***Planning application
response***

RM/2020/2399

Re: Planning application **RM/2020/2399** from the developer Taylor Wimpey Ltd. and their agent the Pegasus Group, the application being dated 15th October 2019

Proposal: Full Reserved Matters application for a residential development of 397 dwellings (C3), public open space, landscaping, drainage attenuation areas, access from Bennetts Road, land safeguarded for a new school, and other associated works.

1. Keresley link road

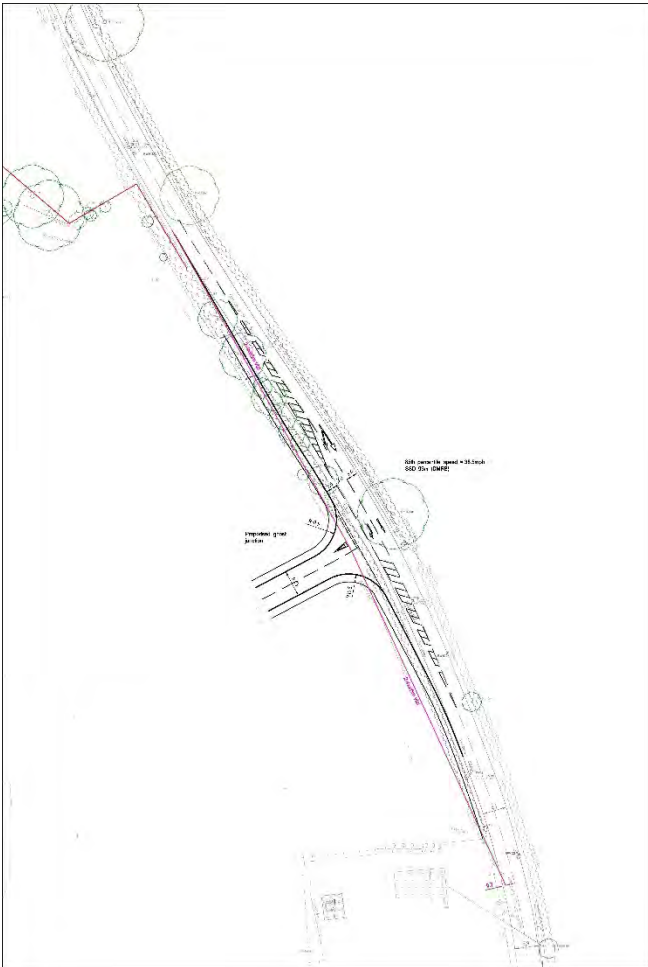
Keresley Parish Council consider the provision of the link road within the SUE, as required in the Local Plan, to be of prime importance in enhancing the local road infrastructure.

At peak hours traffic tailbacks occur within Keresley. The addition of dwellings in any part of the parish as part of the SUE can only make this situation worse. Stationary vehicles within these tailbacks will inevitably reduce the air quality within the parish.

Since there is still no published plan available for the Link Road, or any guaranteed funding for the provision of the completed Link Road, Keresley Parish Council ask that the application be REFUSED.

Access drawing 968-02 Rev C

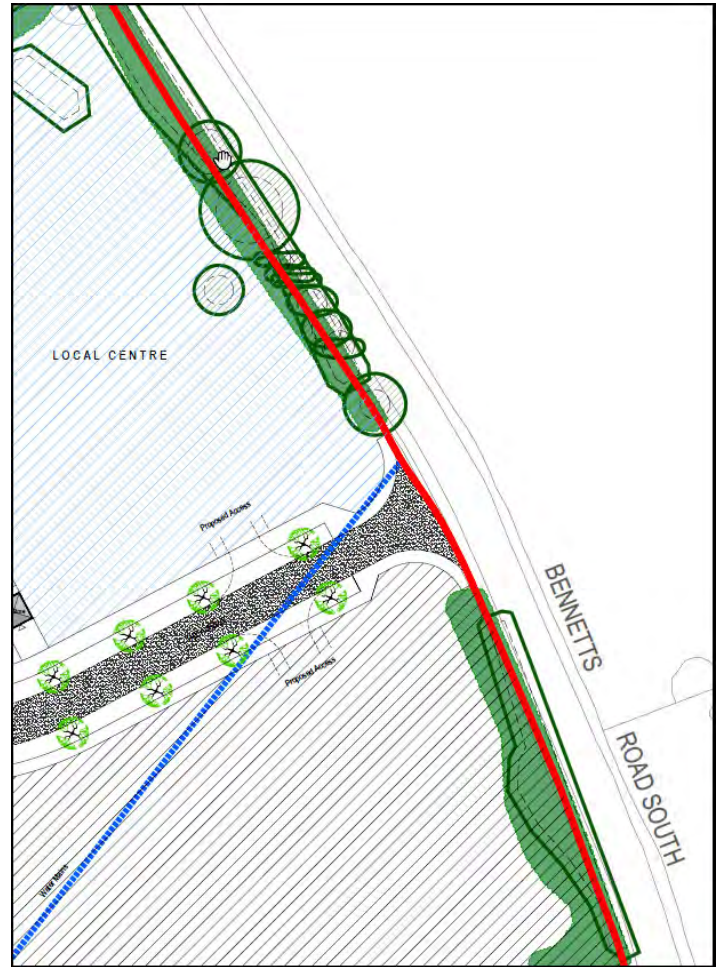
The design for the access road onto Bennetts Road shown in plan - **Proposed Site Layout - Phase 2A and 2B Drawing 100 Rev I**, shows a simple T junction. It fails to abide by the condition detailed in the outline planning application approval to use that shown in drawing **968-02 Rev C**.

The drawing 968-02 Rev C includes for a ghost lane for traffic turning right into the development. The Taylor Wimpey proposal fails to implement this access road plan.

Since the proposed design fails to abide by the use of plan 968-02 Rev C for the Bennetts Road entrance, as required in Condition 5a of the approval for OUT/2014/2282, Keresley Parish Council ask that the application be REFUSED.

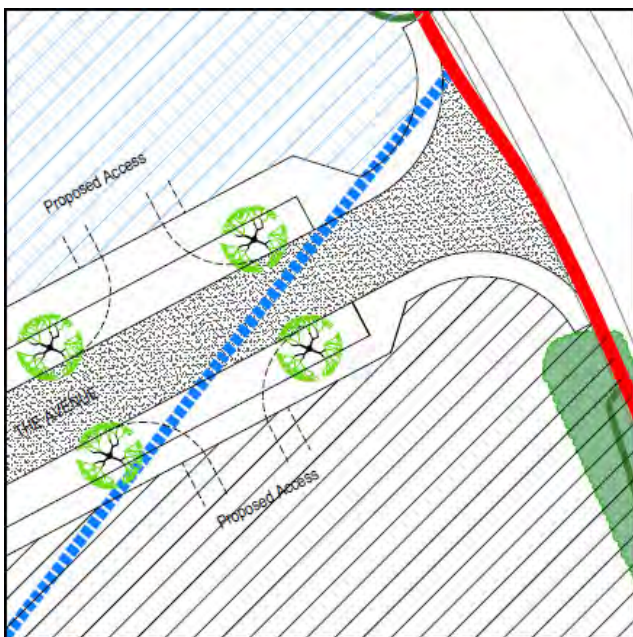
The proposed vehicle access to the school is shown as being opposite that of the Local Centre.

To the Parish Council having a vehicle entrance for the school at this location appears to be a dangerous proposal.

A more appropriate position might be from the Internal Road which leads from the Focal Junction 4.

The masterplan drawing B0263-6-1E showed a roundabout where Focal Junction 4 is now shown.

A roundabout here might be more appropriate for a vehicle entrance to the school.

5. The Avenue

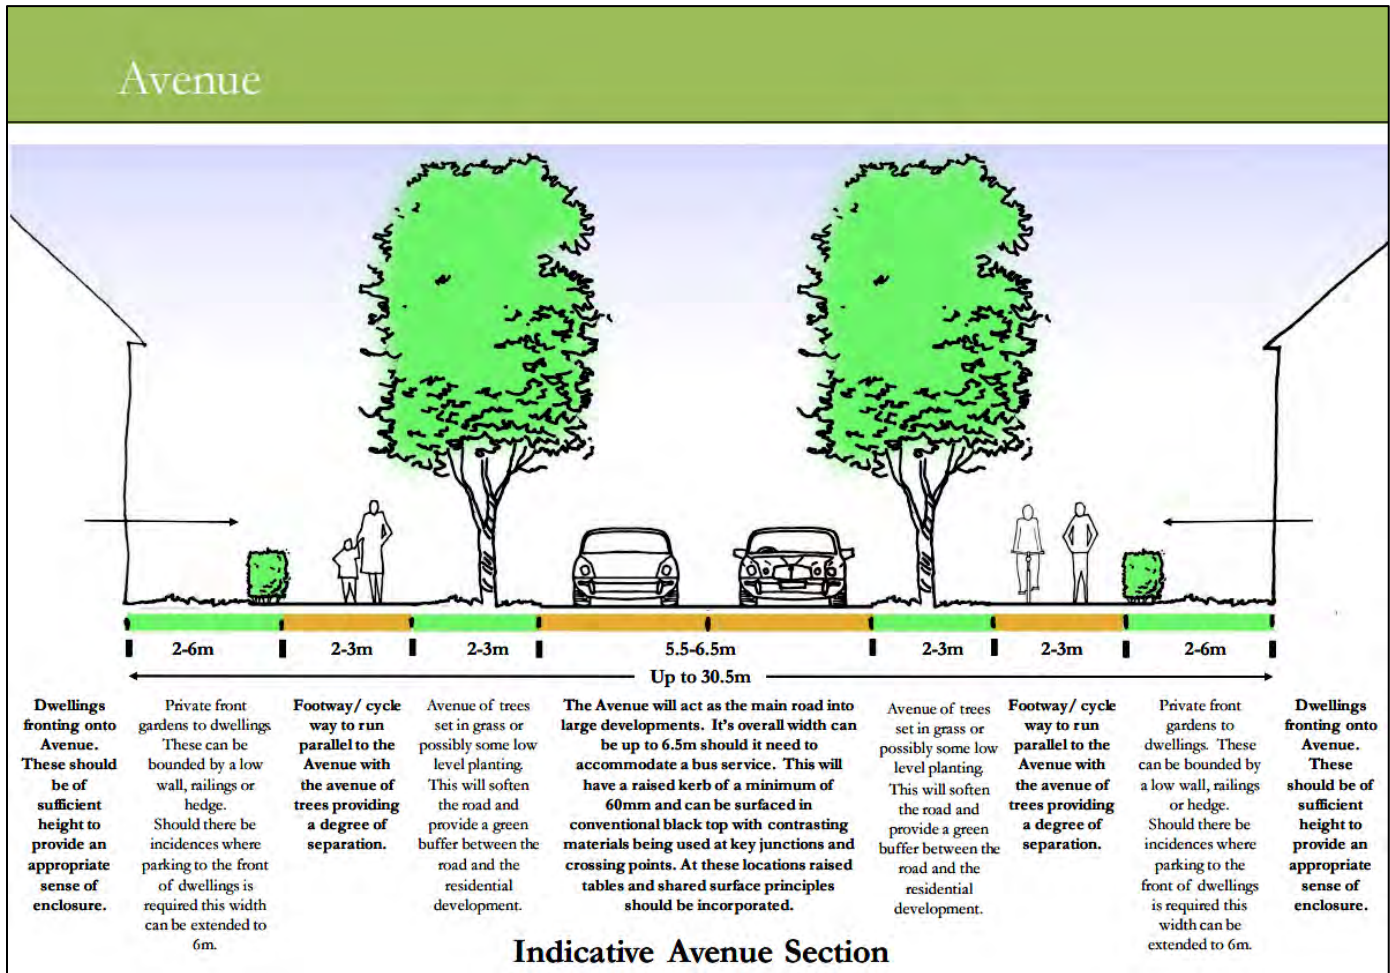
The image above shows a cross section of an Avenue road type detailed on page 40 of the SPD. This details a Footway/Cycleway on both sides of the Avenue spine road,

However, the design implementation by Taylor Wimpey, as shown in **Proposed Site Layout - Phase 2A and 2B - Drawing 100 Rev I** drawing, only implements the provision of a Footway/Cycleway on one side of the road.

The design implementation by Taylor Wimpey, **Proposed Site Layout - Phase 2A and 2B - Drawing 100 Rev I**, shows the Avenue road, 6.5m wide.

To the northwest a 3m wide footpath/cycleway.

To the southeast a 2m wide footpath.

The SPD drawing shown previously details the Avenue as needing a footpath/cycleway on both sides of the road.

Private front gardens to the dwellings is shown as around 1.2m in depth. Again, the SPD drawing shown previously details this as needing to be a minimum depth of 2m.

Since the proposed design fails to implement the SPD requirements for a combined Footway/Cycleway to be provided on both sides of the Avenue spine road, and a distance from this Footway/Cycleway the distance from its edge to dwellings to be at least 2m, Keresley Parish Council ask that this application be REFUSED.

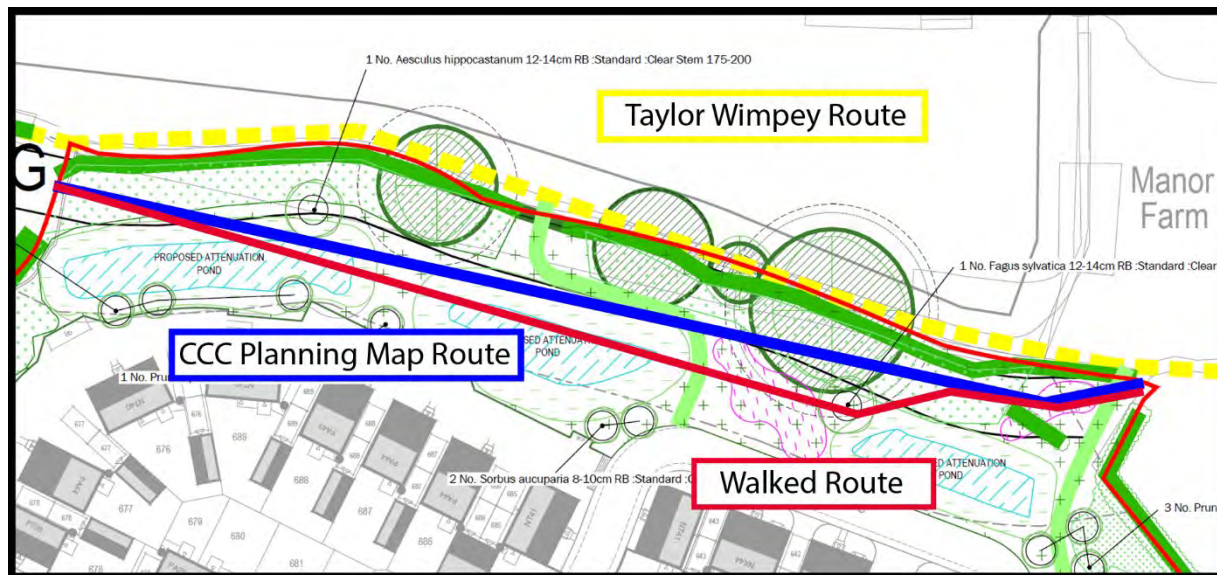
Below is an extract from the *environmental dimension partnership drawing Landscape General Arrangement – Phase 2* (edp4592_d013i Sheet 6 dated 16th September 2020) showing, in yellow, the public right of way (PRoW), in the North of the site near Manor Farm. Two additional path routes are shown in blue and red.

In **yellow** is the Taylor Wimpey interpretation of the route of the ProW where one is expected to walk through hedgerows and tree trunks, the route being shown as being outside or on the border of the proposed development area.

In **blue** is the route of the ProW as shown in the Coventry City Council planning map.

The **red** route of the ProW is the one actually used by walkers in order to avoid the low crown of the Oak tree in the hedgeline.

In the Taylor Wimpey plan the actual public right of way route is shown as being blocked by areas of bulb planting, wild flower grassland, wetland shrubs, a *Fagus sylvatica* (Common Beech) tree and attenuation ponds. All of these environmental proposals are desirable but they should not be blocking a ProW.

Since the proposed design shows the ProW being blocked rather than retained, Keresley Parish Council ask that this application be REFUSED.

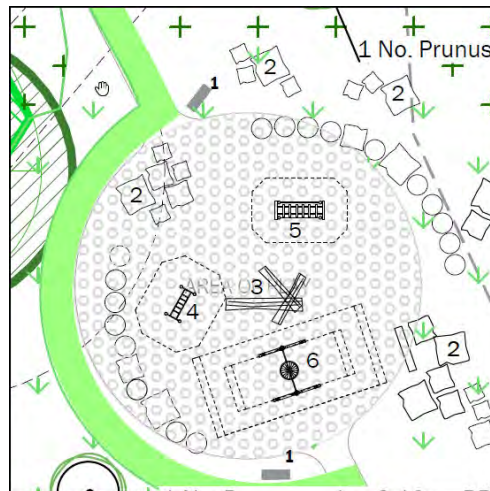
Like the initial plan provided for Phase 1, this phase 2 plan makes no provision for buses neither at the Bennetts Road entrance nor along the spine road. Whilst the outline application

Since the application fails to provide a **Transport Assessment**, and no public transport links within the development, Keresley Parish Council ask that this application be REFUSED.

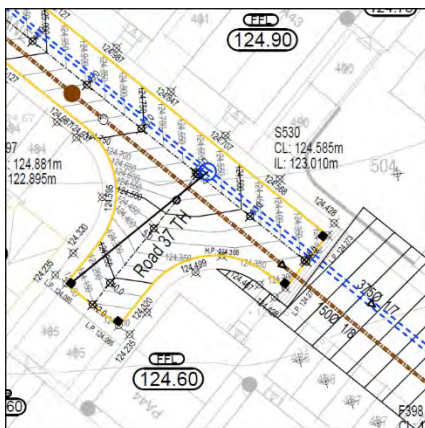
The Play Area shown in drawing **Landscape General Arrangement – Phase 2** (edp4592_d013i Sheet 7 dated 16th September 2020) is adjacent to an Internal Road. It is shown to have no boundary fencing in drawing **Boundary Treatment Phase 2B Drawing 108 Rev D**.

This is an Internal Road so traffic could be light. This may lull children into a false sense of security who then fail to observe the rules for crossing the road when needed. A roadside boundary fence is needed for the safety of children playing.

Since the design proposes an unsafe environment for children, Keresley Parish Council ask that this application be REFUSED.

T62 – Oak

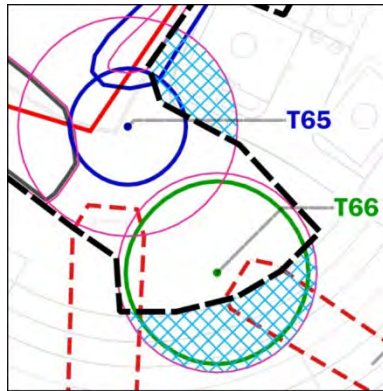
*Encroachment into RPA
by access drive*

T65 – Ash T66 – Oak

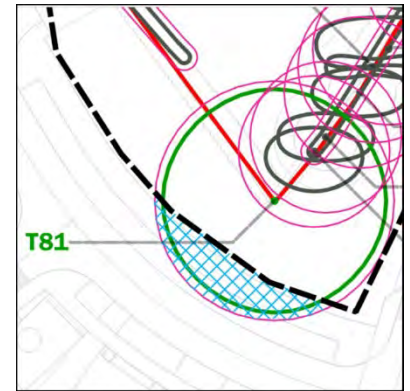
*Encroachment into to
RPA by residential unit
(T65) and road (T66)*

T81 – Oak

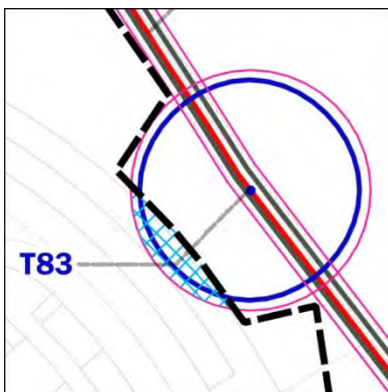
*Encroachment into RPA
by road*

T83 – Ash

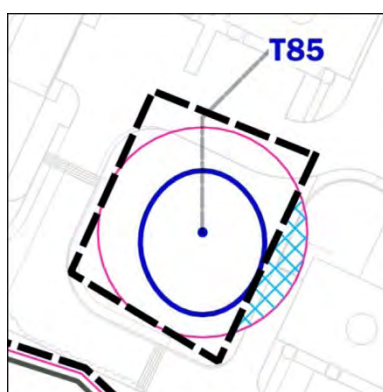
*Encroachment into RPA
by road*

T85 – Oak

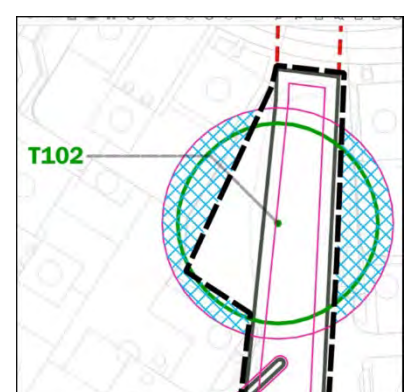
*Encroachment into to
RPA by residential unit
and access drive*

T102 – Oak

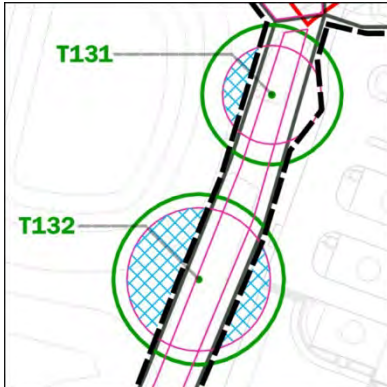
*Encroachment into to
RPA by residential unit
and access drive*
